Access Compliance Report

Public Rights-of-Way

(Curb Ramps)

Intersection ID: 10597	Main Street: BELLE_PLAINE_DR	Cross Street: BRIARGROVE_DR	Location: SW
ADA ID: 9C635D6A67DD	Ramp Type: Directional1	Initial Pass/Fail: Pass	Overall Compliance: No
		Severity Score: 0

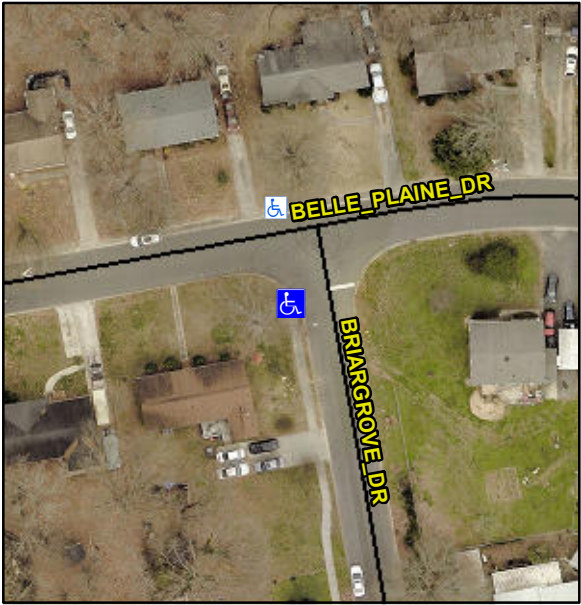
Codes/Mitigation Info/Possible Solution			Field Measurements/Component Compliance			
	Possible Solutions:		Compliance	Description	Data	
	Remove & Replace Entire Ramp.		N/A	Ramp Length (in)	108.5	Yes
			Yes	Ramp Width (in)	60.0	No
			Yes	Ramp Slope (%)	5.8	Yes
			Yes	Ramp XSlope (%)	1.4	
			N/A	Flare Type LT	N/A	N/A
			N/A	Flare Slope LT (%)	N/A	N/A
			N/A	Flare Traversable LT?	N/A	N/A
	Surveyor Notes:		Yes	Landing Length (in)	60.0	Yes
	N/A		Yes	Landing Width (in)	60.0	Yes
			Yes	Landing Slope (%)	0.3	Yes
			Yes	Landing X Slope (%)	1.7	Yes
	PROW/ADA:		N/A	Landing Curb? (Y/N)	N/A	No
	Not Found, R304.5.3, R305.2		N/A	Shared Landing?	No	No
			Yes	Gutter Ponding?	No	Yes
			Yes	Gutter Lip Ht (in)	0.0	Yes
			N/A	Painted X Walk1?	No	
				X Walk 1 Direction	To N	
				X Walk 1 Width (in)	N/A	
				X Walk 1 Slope (%)	0.6	N/A
				X Walk 1 X Slope (%)	6.3	Yes
			N/A	Ramp inside XWalk1?	N/A	
			Yes	Any Obstructions?	No	
				Obstruction Type

Total Cost:		\$ 1600.00				
			Yes	Surface Condition? (G/P)		Good
			N/A	Curb Slope (%)		9.5
